Salem Generating Station Units 1 and 2
Renewed Facility Operating License Nos. DPR-70 and DPR-75
NRC Docket Nos. 50-272 and 50-311

Subject: Response to Request for Additional Information for Proposed Alternative for Examination of ASME Section XI, Examination Category B-B, Item Number B2.11 and B2.12

Response to Requests for Additional Information
Salem Generating Station Units Nos. 1 and 2
Regarding Alternative for Examination of ASME Section XI,
Category B-B, Item Number B2.11 and B2.12
EPID L-2020-LRR-0103

Figure RAI-1-1: Applied K vs. Fracture Toughness as a Function of Temperature for Case ID PRSHC-BW-2C
(Using Plant-Specific Maximum Pressurizer Material RT_{NDT} Value of $10^{\circ}F$)

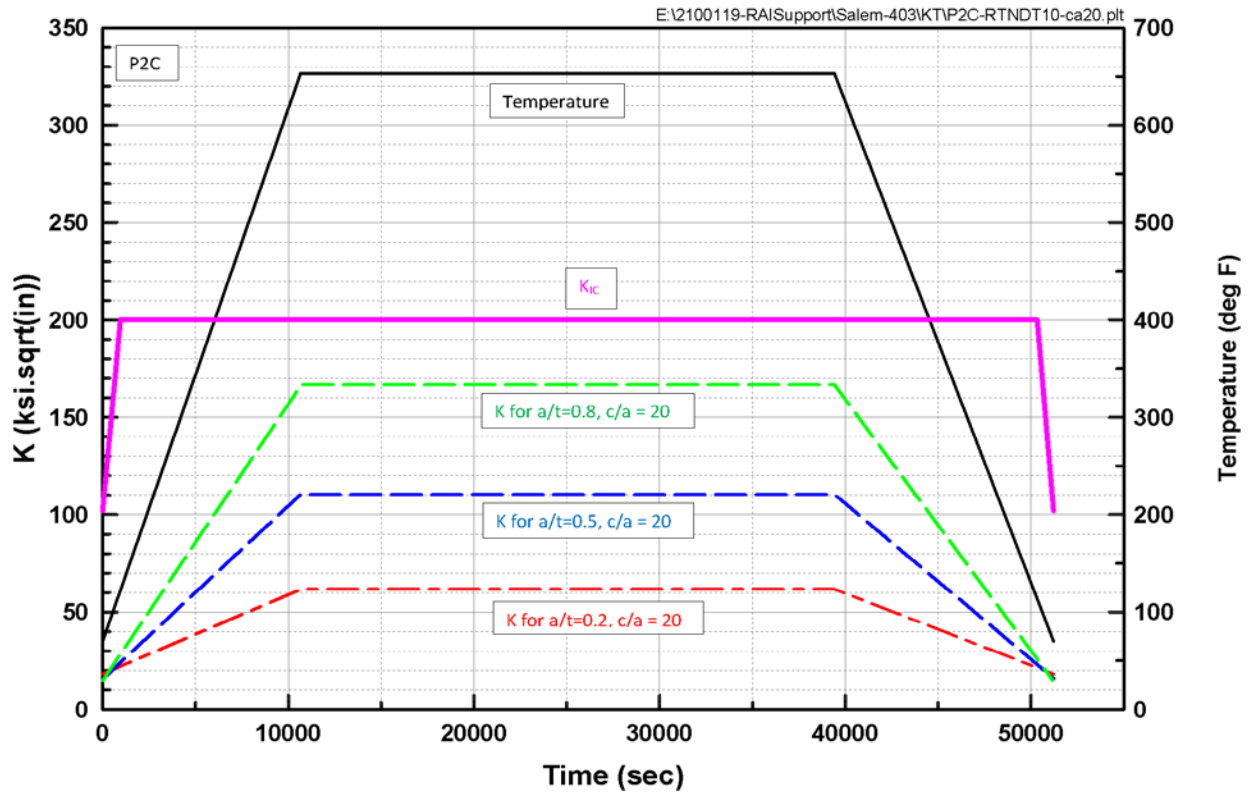
Table 5-6 of EPRI report 3002015905 shows that the temperature of the pressurizer (TPZR in the table) applicable to the Examination Item Numbers B2.11 and B2.12 PZR SHWs of Salem Units 1 and 2 requested in the submittal ranges from 70°F to 653°F for the Heatup/Cooldown transient. Section 8.2.2.6 of EPRI report 3002015905 explains that a fracture toughness (KIC) set at the upper shelf value of the ASME Code KIC curve, 200 ksi√in, may be used. In the audit summary report for PROMISE Version 1.0 (ADAMS Accession No. ML20258A002, Item No. 2.e.iii), the NRC staff observed that for the steam generator feedwater nozzle, KIC could be as low as 130 ksi√in during the Heatup/Cooldown transient and that this lower value of KIC is addressed by the sensitivity study on fracture toughness in Tables 8-13 and 8-14 of non-proprietary EPRI Report No. 3002014590, "Technical Bases for Inspection Requirements for PWR Steam Generator Feedwater and Main Steam Nozzle-to-Shell Welds and Nozzle Inside Radius Sections", April 2019 (ADAMS Accession No. ML19347B107). The NRC staff noted that the lowest KIC value, 80 ksi√in, used in the sensitivity study on fracture toughness in EPRI report 3002015905 is the same as the lowest KIC value used in the sensitivity study on fracture toughness in EPRI report 3002014590. However, the NRC staff noted that the pressure for the B2.11 and B2.12 PZR SHWs of Salem Units 1 and 2 is more than twice the pressure analyzed for the SG feedwater nozzle in EPRI report 3002014590 since these welds are on the primary

side of the reactor coolant system. Since the pressure is more than twice than what was previously analyzed for the SG feedwater nozzle, the staff cannot determine how much lower than 200 ksi in the K_{IC} value could be during the ramp periods in the beginning and ending of Heatup/Cooldown transient for the subject PZR SHWs.

Given the NRC staff's observations discussed above for the B2.11 and B2.12 PZR SHWs of Salem Units 1 and 2, explain how the sensitivity study on fracture toughness in EPRI report 3002015905 addresses the low K_{IC} value that could exist during the ramp periods in the beginning and ending of the Heatup/Cooldown transient for the subject PZR SHWs.

From the deterministic fracture mechanics (DFM) results in Table 8-4 of EPRI Report 3002015905, the critical Case ID for Item Nos. B2.11 and B2.12 is PRSHC-BW-2C (both with and without surge nozzle piping moments). This Case ID also shows the most sensitivity to fracture toughness in the probabilistic fracture mechanics (PFM) evaluation as presented in Tables 8-15, 8-16 and 8-32 of EPRI Report 3002015905. Therefore, Case ID PRSHC-BW-2C was selected for an additional evaluation to respond to this RAI request.

The stress intensity factor (K) and temperature histories at the inside surface for Case ID PRSHC-BW-2C for the Heatup/Cooldown transient (including RCS pressure) are provided in Figure RAI-1-1 for three flaw depths that span the range of depths covered in the evaluation ($a/t = 0.2, 0.5$ and 0.8). Based on a review of the supporting calculations, the maximum aspect ratio (crack half-length over depth, or c/a) from the DFM evaluation performed in Section 8.2 of EPRI Report 3002015905 for this Case ID ranged from approximately 1.7 to 3.6. A conservative (longer flaw) aspect ratio, c/a , of 20 was selected for use in this evaluation.

The stress intensity factor time histories were calculated for the three flaw depths for the Heatup/Cooldown transient, and the fracture toughness history for the transient was calculated using the equation for K_{IC} in Paragraph A-4200 of Nonmandatory Appendix A of ASME Code, Section XI. A maximum plant-specific RT_{NDT} of 10°F was used for the Salem Units 1 and 2 pressurizers based on a review of all plant-specific pressurizer certified material test reports (CMTRs) and fabrication inspection reports. As shown in Figure RAI-1-1, the calculated applied Salem-specific stress intensity factors are bounded with margin by the corresponding K_{IC} calculated as a function of temperature throughout the transient, for all three flaw depths.

Figure RAI-3-1: Time History Stresses (Pressure Plus Thermal) at the Inside Surface for Path P2 for the Heatup/Cooldown Transient

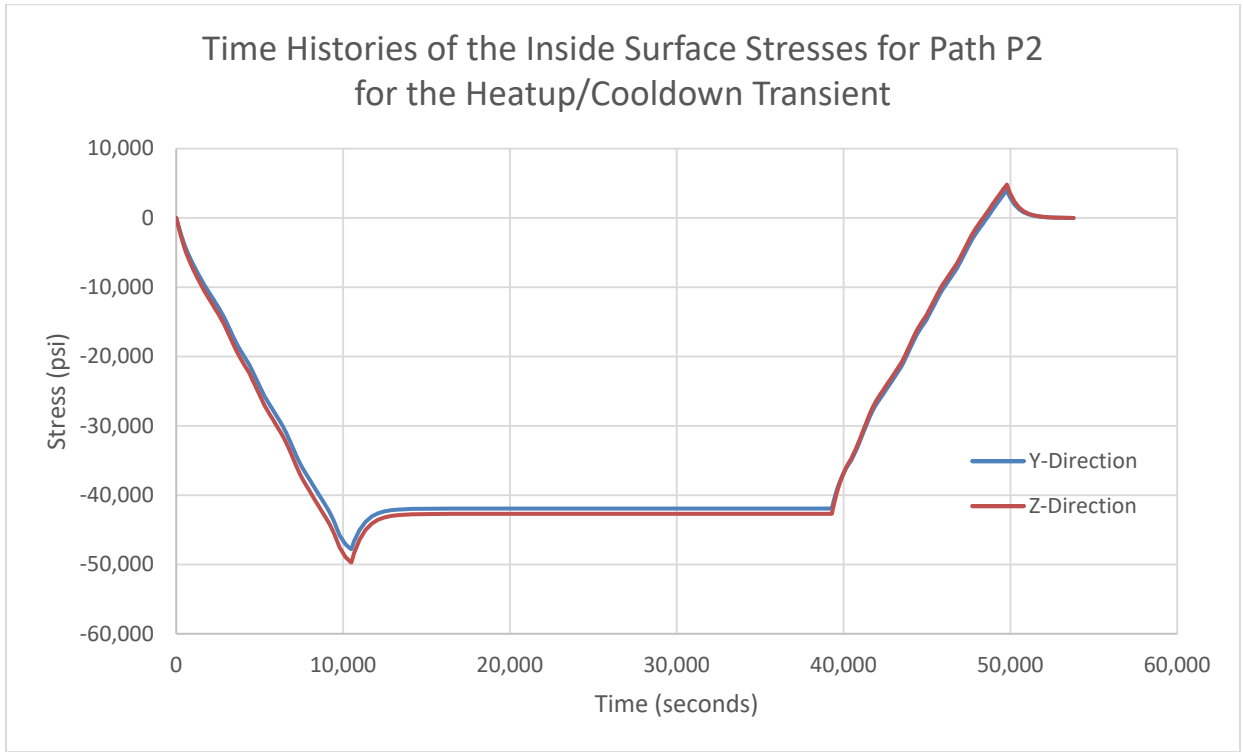
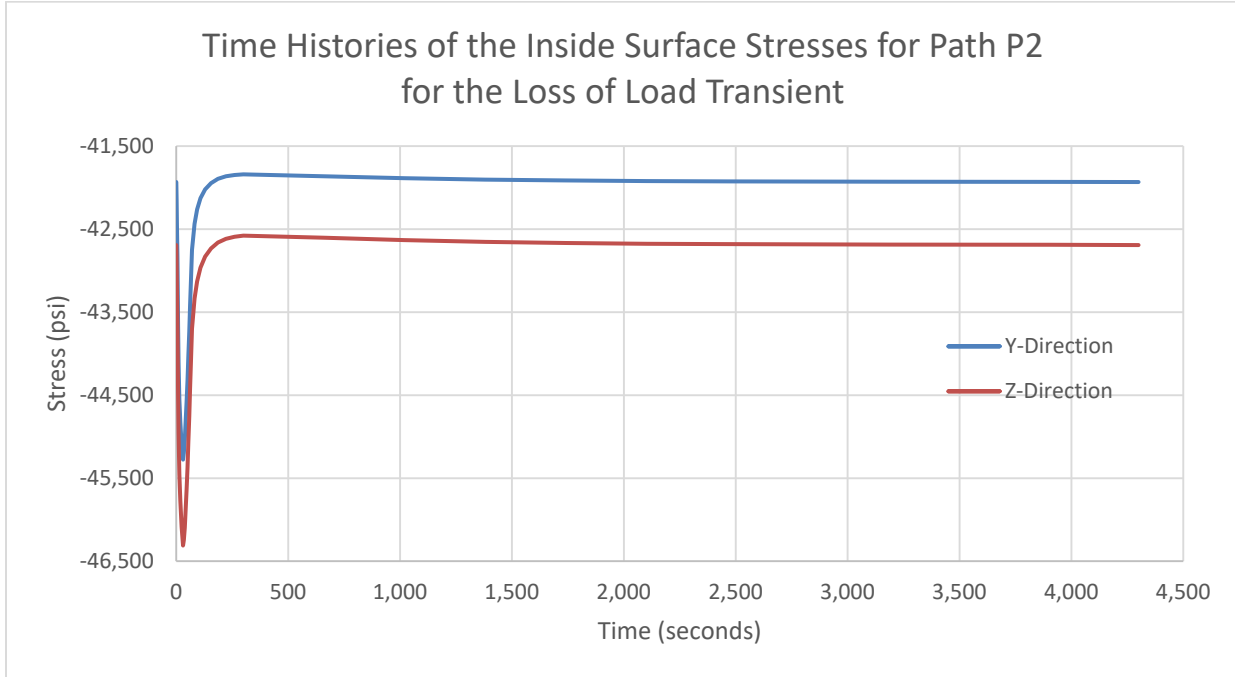
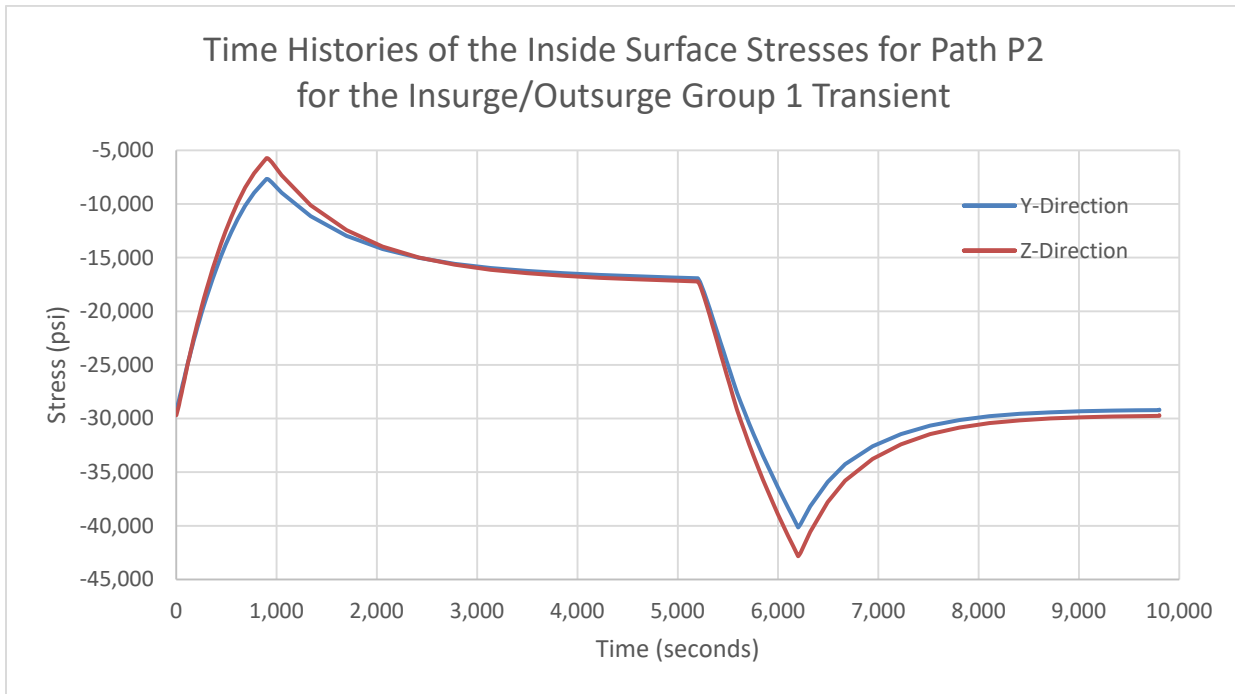
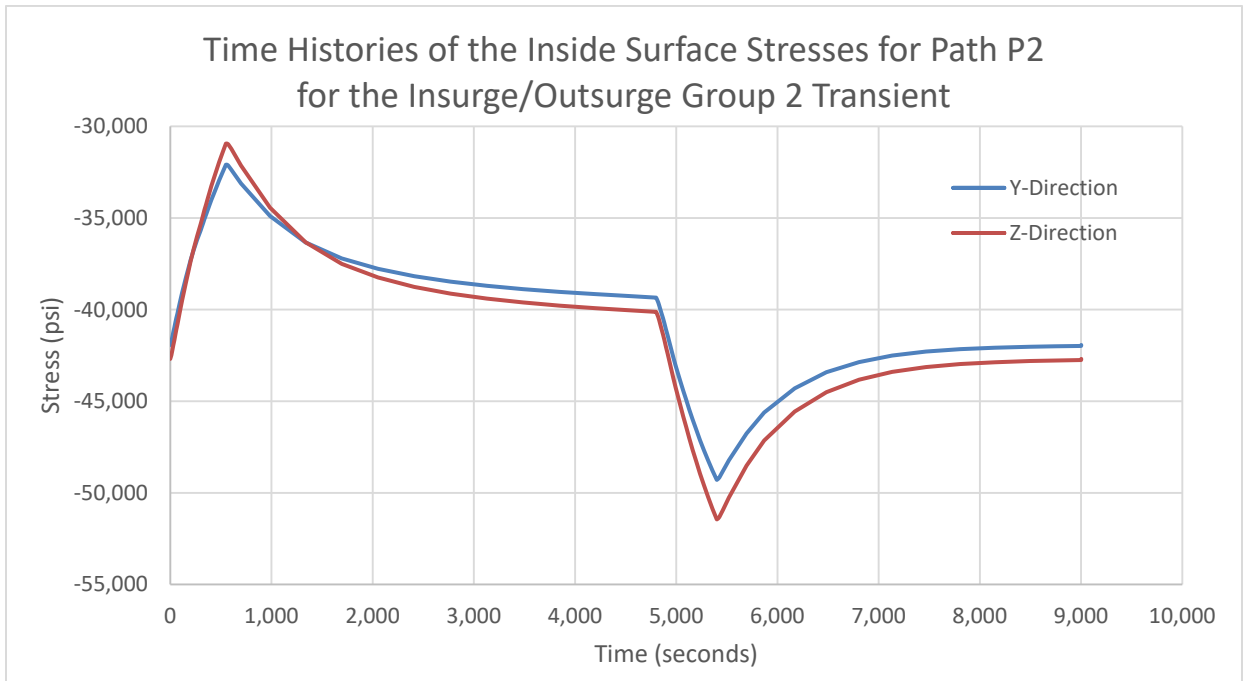
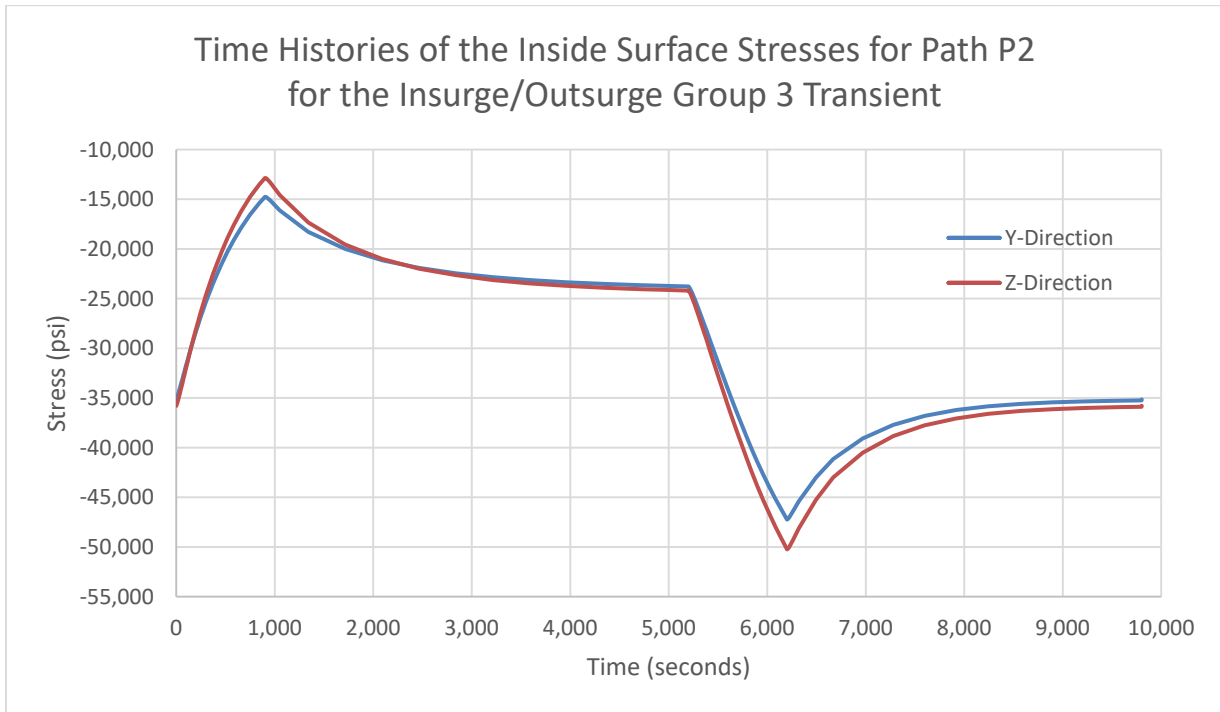
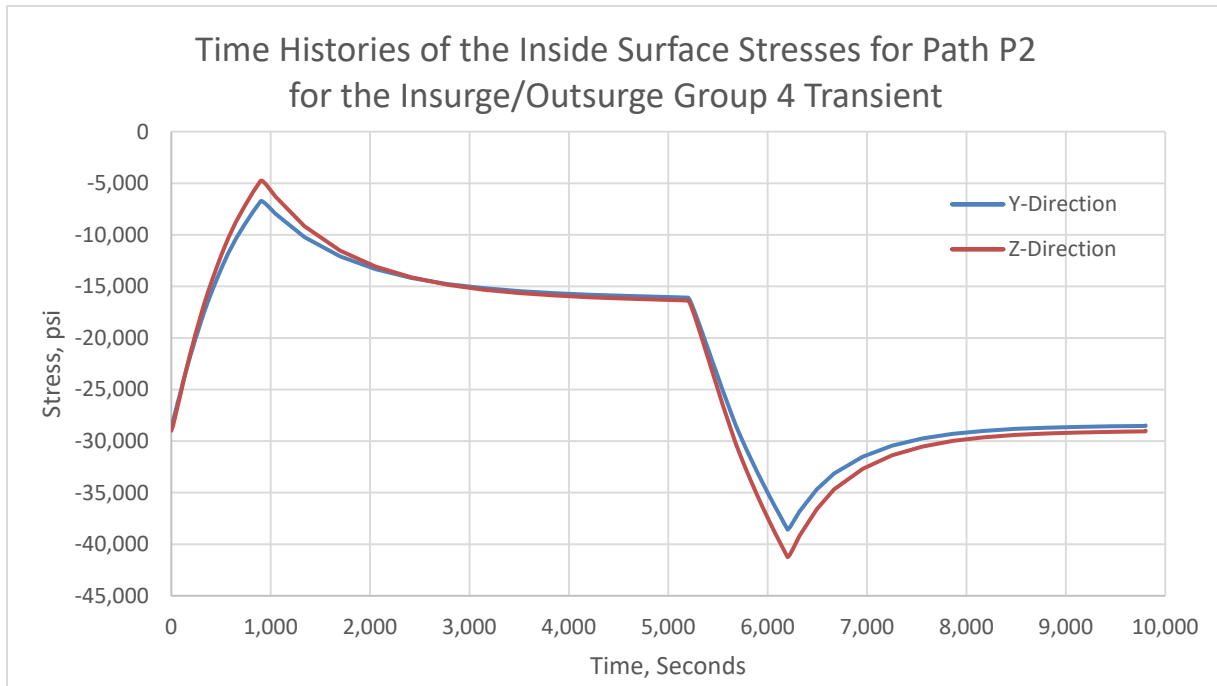
The through-wall stress distribution plots for the thermal transients in Figures 7-10 and 7-11, 7-22 through 7-25 of EPRI report 3002015905 for the subject PZR welds show compressive stresses at the inner surface. However, tensile stresses at the inside surface are typically expected for transients that have temperature drops, such as the Insurge/Outsurge transients listed in Table 5-9 of EPRI report 3002015905 and the Loss of Load transient in Table 5-6 of EPRI report 3002015905.

To assure that the thermal stress behavior in the subject PZR welds analyzed is reasonable, explain if the thermal stresses on the inside surface shown in the referenced figures of EPRI report 002015905 become tensile at times other than those shown in the figures.

The general trends are similar in all the through-wall stress profiles in Figures 7-10, 7-11, 7-22, 7-23, 7-24 and 7-25 of EPRI Report 3002015905. Therefore, the limiting stress path was selected for illustration in this response. Based on the results of the deterministic fracture mechanics (DFM) evaluation summarized in Section 8.2.3 and Table 8-4 of EPRI Report 3002015905, the limiting stress path is Path P2 for the pressurizer lower head-to-vessel weld. Path P2 is shown in Figure 7-9 of EPRI Report 3002015905. Inside surface stress histories were generated for limiting stress Path P2 for all six of the evaluated transients listed in Tables 5-6 and 5-9 of EPRI Report 3002015905 (Heatup/Cooldown, Loss of Load, and Insurge/Outsurge Groups 1 through 4 transients). These six plots are shown in Figures RAI-3-1 through RAI-3-6. The stress histories in these figures can be compared to the stress profiles shown for Path P2 in Figure 7-11 of EPRI Report 3002015905.

For the Heatup/Cooldown transient stress histories shown in Figure RAI-3-1, the inside surface stress is zero at the start of the transient because there is no differential thermal expansion between the stainless steel cladding and the low alloy steel base material for the assumed, stress-free temperature of 70°F. Then, a significant compressive stress develops during the heatup because of the differential thermal expansion between the cladding and the base material as the temperature increases. The compressive stress reaches a maximum steady state value after 10,000 seconds when the heatup is complete. The stress then reverses during the cooldown that begins just before 40,000 seconds and becomes tensile at the end of the cooldown near the end of the transient (at 50,000 seconds).

All other transients (the Loss of Load and the four Insurge/Outsurge Groups) start with the pressurizer hot and therefore, the inside surface at the start of these transients is in significant compression due to the differential thermal expansion between the stainless steel cladding and the low alloy steel base material based on the stress-free temperature of 70°F. As shown in Figures RAI-3-2 through RAI-3-6, the stresses on the inside surface during these transients become less compressive because of the cooldowns that occur in each of the transients, but the temperature drops are not high enough during the transients for the inside surface stresses to become tensile.

Therefore, the thermal stress behavior in the analyzed pressurizer welds are reasonable in that they follow expected behaviors based on the inputs used in the evaluation.

Figure RAI-4-1: Initial Flaw Size Distributions

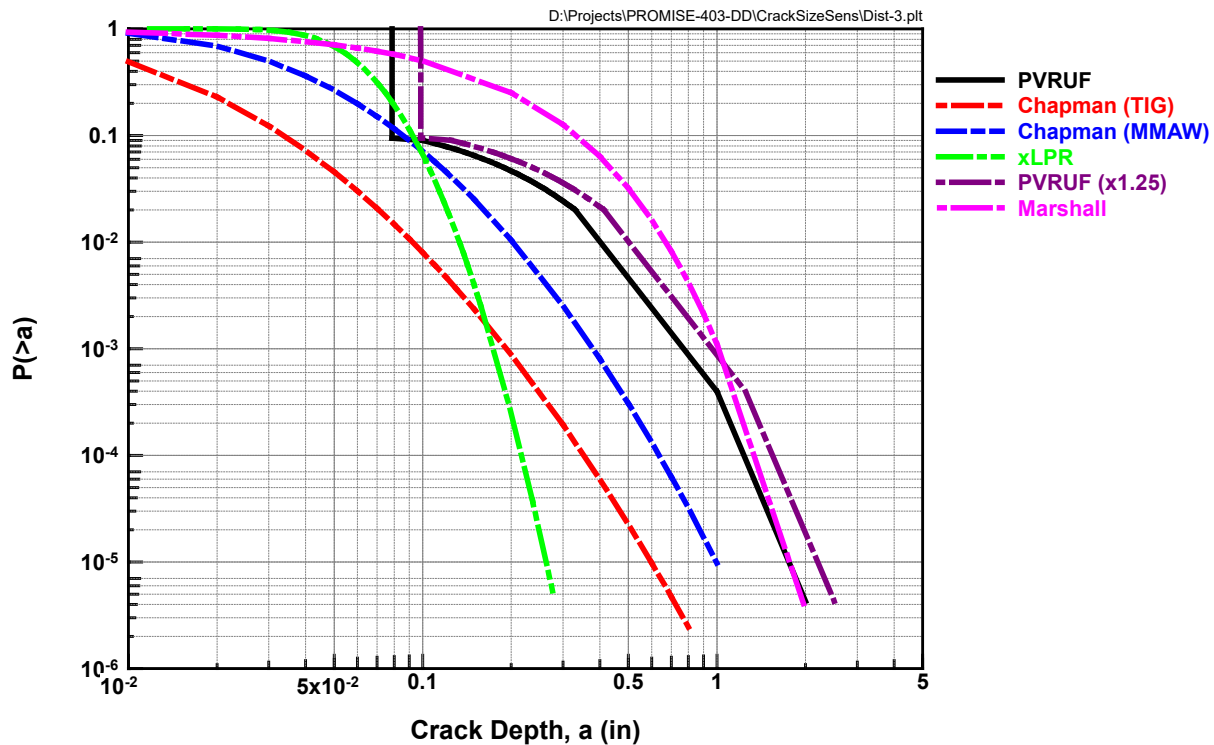
In Section 8.3.2.2 of EPRI report 3002015905, EPRI stated that the flaw distribution derived from flaw data from the Pressure Vessel Research User's Facility (PVRUF) vessel was applied to the PZR vessel in the analyses. NUREG-6471 "Characterization of Flaws in U.S. Reactor Pressure Vessels," (ADAMS Accession No. ML112510316, Reference 89 of EPRI report 3002015905) states that the PVRUF vessel is from an unused pressurized water reactor (PWR) vessel and that the PVRUF data are from fabrication flaws in the PVRUF vessel weldment. The nominal thickness of PWR vessels is 8 inches. Figure 4-4 of EPRI report 3002015905 shows the PZR vessel lower head model used in the analyses referenced for the Salem Units 1 and 2 SHWs in the PZR lower head; the figure shows that the PZR vessel cylindrical shell (vertical portion) is relatively thick, but the PZR lower head is only 2.55 inches thick. The staff noted that the PVRUF flaw data may not be appropriate for vessels much thinner than 8 inches since welding thinner vessels is different from welding thick vessels. Furthermore, Table A-1 in Attachment 1 to the submittal states that the upper and lower head of the Salem Units 1 and 2 PZR are made of SA-216 Grade WCC, which is different from SA-533 and SA-508 Class 2 materials typically used for reactor pressure vessels. Section 8.3.2.2 of EPRI report

Justify that the flaw distribution based on the PVRUF flaw data from a reactor pressure vessel is appropriate for the Salem Units 1 and 2 PZR vessel lower SHWs.

Five of the above initial flaw size distributions are plotted in Figure RAI-4-1, where the probability of finding a flaw greater in size than depth, a , or $P(>a)$, is plotted as a function of the flaw depth, a . Flaw distribution #6 (the "Theoretical" flaw distribution) would plot as a vertical line in this figure. For example, for the pressurizer lower head, the vertical line would occur at a crack depth, a , of 0.64 inches for all $P(>a)$ values (based on 25% of the minimum pressurizer lower head thickness of 2.55 inches shown in Table 4-4 of EPRI Report 3002015905).

It is noted that vessel flaw distributions (PVRUF or the shifted PVRUF) are considered to be most appropriate for application to the pressurizer because the pressurizer is a vessel with similar geometry, material and fabrication practices as those used to fabricate RPVs. On the other hand, the xLPR flaw distribution is applicable to dissimilar metal welds, which are not present in the subject pressurizer welds. Nevertheless, useful insights can be gained by comparing the probabilistic fracture mechanics (PFM) results from all six of the above flaw distributions to estimate the sensitivity in the PFM results from differences in the geometry, material, and fabrication practices that were assumed in each flaw distribution model.
